| Application No: | Consultees Name: | Received: | Comment: | Response: |

REF CAMDEN BC PLANNING APPLICATION 2024/5410/P 72 CAMDEN MTNS

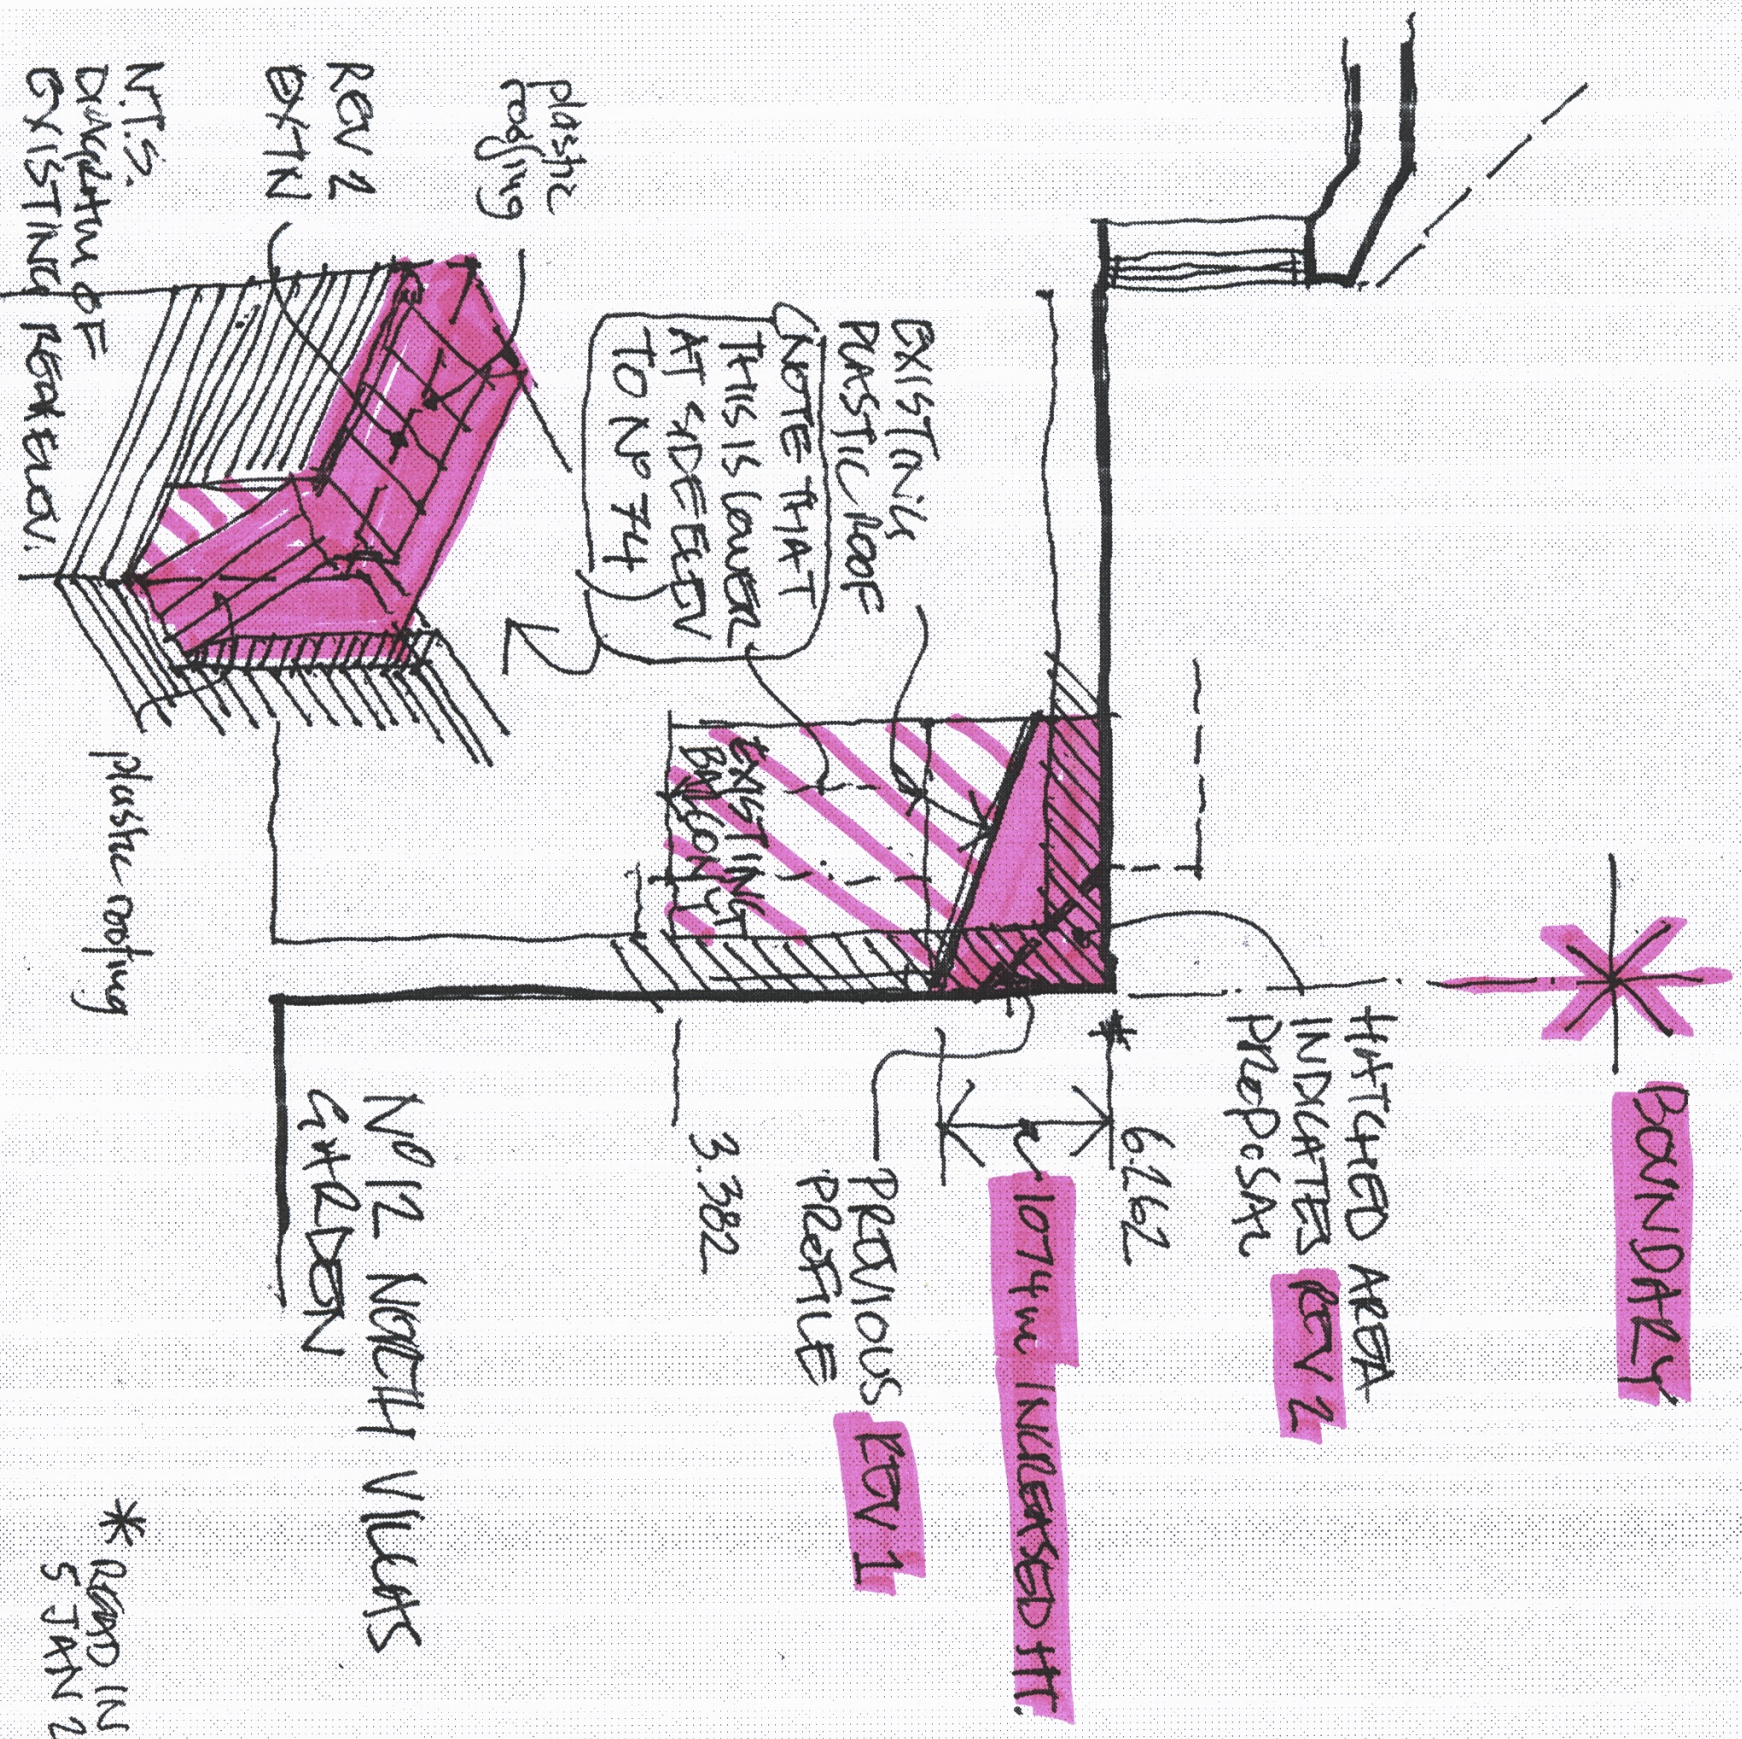
| Application No: | Consultees Name: | Received: | Comment: | Response: |
|-----------------|------------------|---------------------|----------|--|
| 2024/5410/P | Norman King | 05/01/2025 12:56:22 | COMMNT | <p>1- The revision to the application has failed to address previously submitted concerns regarding the impact of the proposed extension/alterations to the rear of the property and there is no update of the diagram included in the Design Access Statement which attempts to compare the existing with the original rev 1 proposal. This should now compare with the latest revision 2.</p> <p>2- Rather than ameliorating the impact, it has been exacerbated by removal of the sloping roof profile which is not shown as amended on their drawings. The previously submitted drawings have been removed from the Camden Application website which has made it difficult to identify all of the amendments in detail. Please compare sections 2 and 3 on drawing CAM-CS-ZZ-DR-A-0501 Rev 1 with the latest revision 2. The proposal was not acceptable in revision 1 and cannot therefore be considered acceptable in Revision 2.</p> <p>3- From reference to datum levels given on the submitted drawings, this shows the proposed increase in height on the rear boundary line with No 12 North Villas, to be 1074mm. This is taken from the existing plastic roof eaves which is itself a questionable previous extension/alteration as described below, (para 4).</p> <p>4- It should be noted that the existing building includes, (at first floor level), what is described as a 'balcony'. At some point this became enclosed with what appears to be a temporary 'plastic' type construction, and may not have been part of a previous Planning Approval or Building Control consent. Materials used suggest this. It should therefore not be seen as a justification for further retention or further vertical extension.</p> <p>5- It should be noted that this property has enjoyed the benefit of having been built originally right up to the rear boundary shared with adjacent properties on North Villas. Had it retained a rear garden, (as is typical for all immediate neighbours along the Mews), it would be reasonable to assume the height of a boundary fence or wall would have been limited to 2.0m. A further increase in height is therefore unacceptable due to its additional shadowing of daylight/sunlight, (and removal of a view of sky), which will impact properties on North Villas and neighbours on Camden Mews. Please note that adjacent properties on North Villas are single level apartments where those at garden and first floor levels will be particularly disadvantaged. At the very least, this is unneighbourly!</p> <p>6- The acoustic performance of the proposed heat pump should be assessed to ensure it does not exceed acceptable limits bearing in mind the proximity this development has to neighbours and the possibility of reflected noise within the corridor formed with North Villas properties.</p> <p>7- This website 'Comment' facility unfortunately does not include the facility to include attachments/drawings. The applicant should be required to provide an accurate comparison to illustrate impact of proposals on the rear of the property. I will endeavour to send a sketch by alternative means.</p> |

* RECD IN CONSULTATION WITH COMMENTS SUBMITTED 5 JAN 2025
